Development and Infrastructure Services Committee Meeting

13 February 2019

LOCAL STRUCTURE PLAN No. 13

SPECIAL RESIDENTIAL AREA No. 10
NANARUP & KULA ROADS, LOWER KING

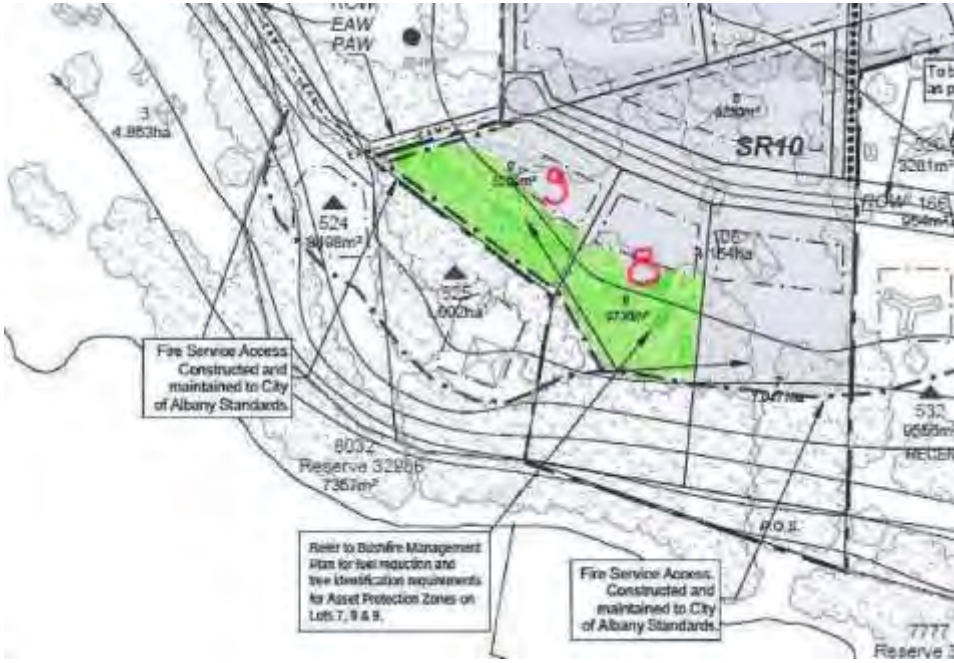
5.	Department of Health	<p>For on-site wastewater disposal systems to be approved, a 'site-and-soil evaluation' (SSE) in accordance with Australian Standard 1547 is required.</p> <p>Approval is required for any on-site waste water treatment process with such proposals being in accordance with DOH publications which may be referenced and downloaded from: http://ww2.health.wa.gov.au/Articles/N_R/Recycled-water http://ww2.health.wa.gov.au/Articles/U_Z/Water-legislations-and-guidelines</p>	<p>It is recommended that the following condition is included on the structure plan map:</p> <p><i>Secondary treatment systems with nutrient removal are required to service development on all proposed lots.</i></p>

<p>For Local Structure Plans, a detailed SSE (guidance note enclosed) is required to determine:</p> <ul style="list-style-type: none"> • identify appropriate treatment technologies and on-site wastewater disposal management systems; • establish performance standards I criteria; and • determine management and monitoring options. 	
ENVIRONMENT

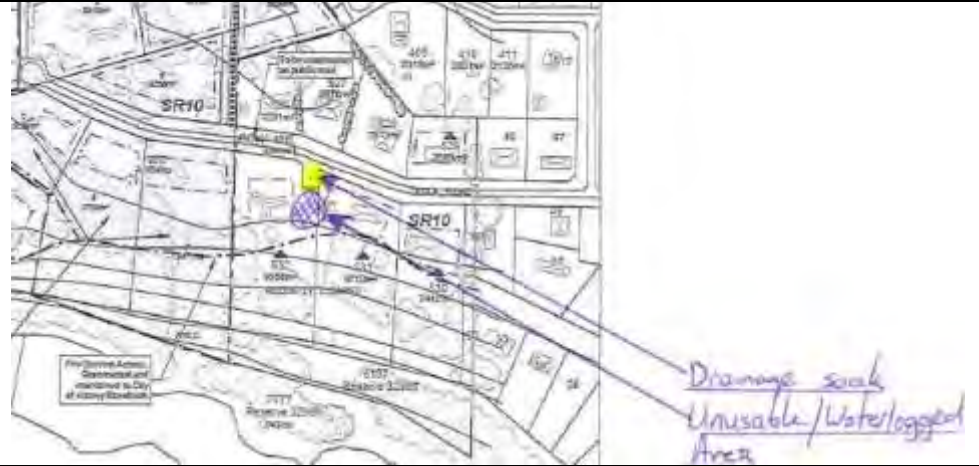
<p>9.</p>		<p>In heavy rain events, a water catchment/drainage soak over flows into 37 Kula Road, making a large wet unusable area.</p> <p>If the road is to be constructed over the ROW to extend Kula Rd, this drainage issue may be accentuated.</p>	<p>Uphold comment relating to stormwater.</p> <p>The subject land slopes toward an existing drainage basin within the road reserve and overflow via a 3m drainage easement on 35 Kula Road. The basin appears to be acting as per the design intent.</p> <p>It is recommended that the following condition is included on the structure plan to ensure stormwater is managed appropriately:</p> <ul style="list-style-type: none"> • At the subdivision stage, a stormwater management plan being developed and implemented to the satisfaction of the City of Albany. The stormwater management plan is to consider the following: <ul style="list-style-type: none"> ○ Design in accordance with the City of Albany Subdivision and Development Guidelines. ○ Retention of hydrology as close as possible to pre-development conditions. ○ Stormwater treatment for minor storm events. ○ Flood management and erosion control.

<ul style="list-style-type: none"> The existing drainage basin on Kula Road may not be suitable to accept additional runoff following the extension of Kula Road. As such, if any additional flows are proposed to the existing system, the developer will be required to review the existing and undertake any necessary upgrades.
BUSHFIRE
